FULLER STATION HOUSING

#	DESCRIPTION	DATE
1	COUNTY REVIEW RESPONSES	10.09.2020
2	ADDENDUM #1	10.09.2020
6	ASI #01	03.03.2021
	RFI 60	07.20.2021
	RFI 68	08.10.2021
	RFI 92	09.10.2021
	RFI 42	09.30.2021
15	ASI #10	11.05.2021
	RFI 148	11.18.2021
	RFI 150	11.18.2021
	RFI 154	11.18.2021
	RFI 155	11.18.2021
17	ASI #12	12.04.2021
	RFI 170	12.06.2021

ENLARGE UNIT
LIGHTING PLANS

E4.04

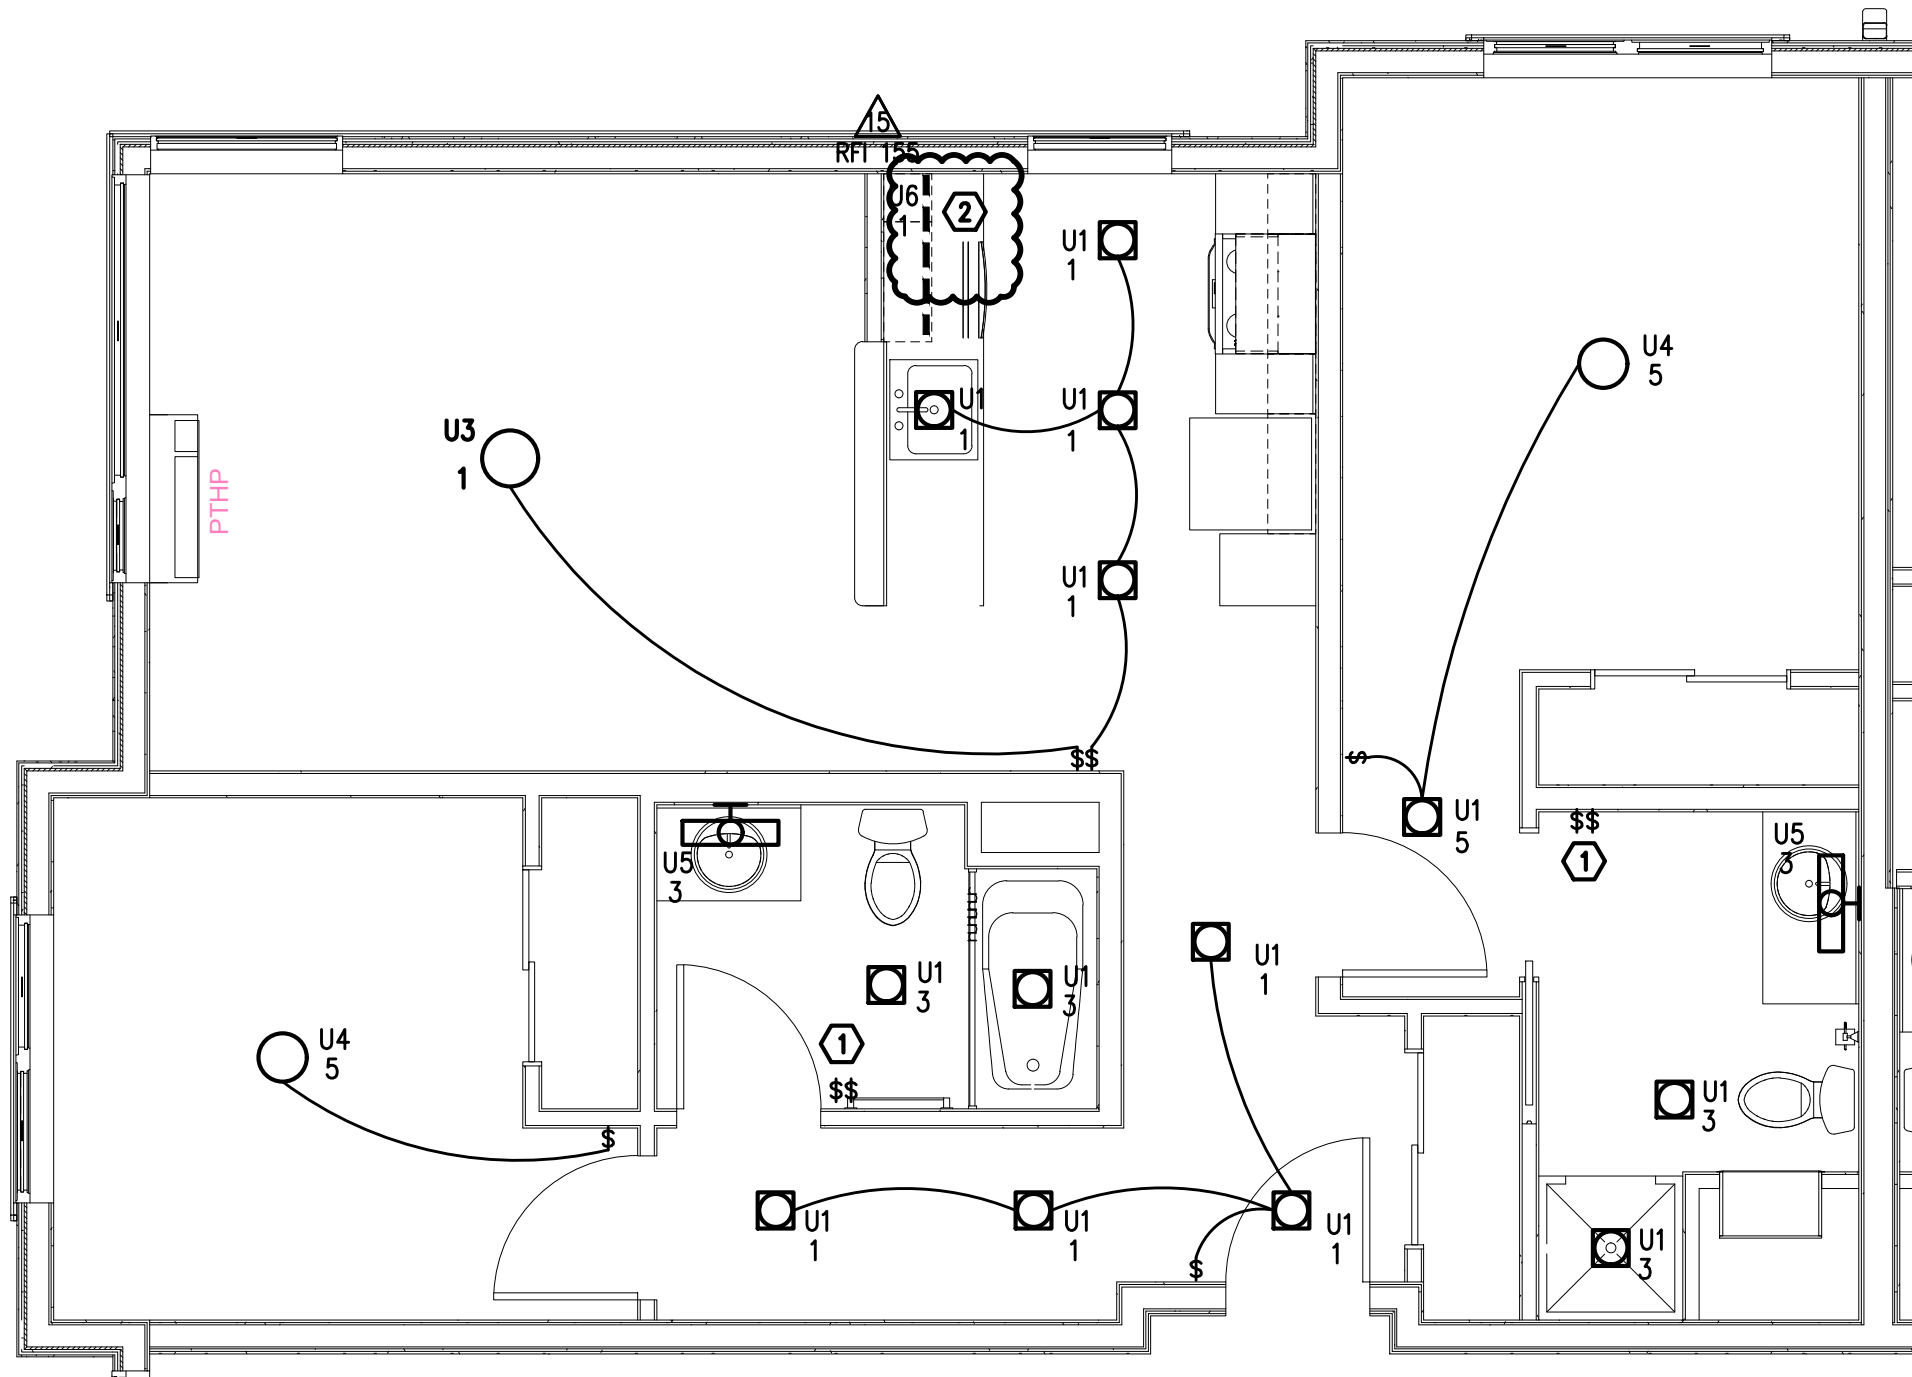
RFI 154
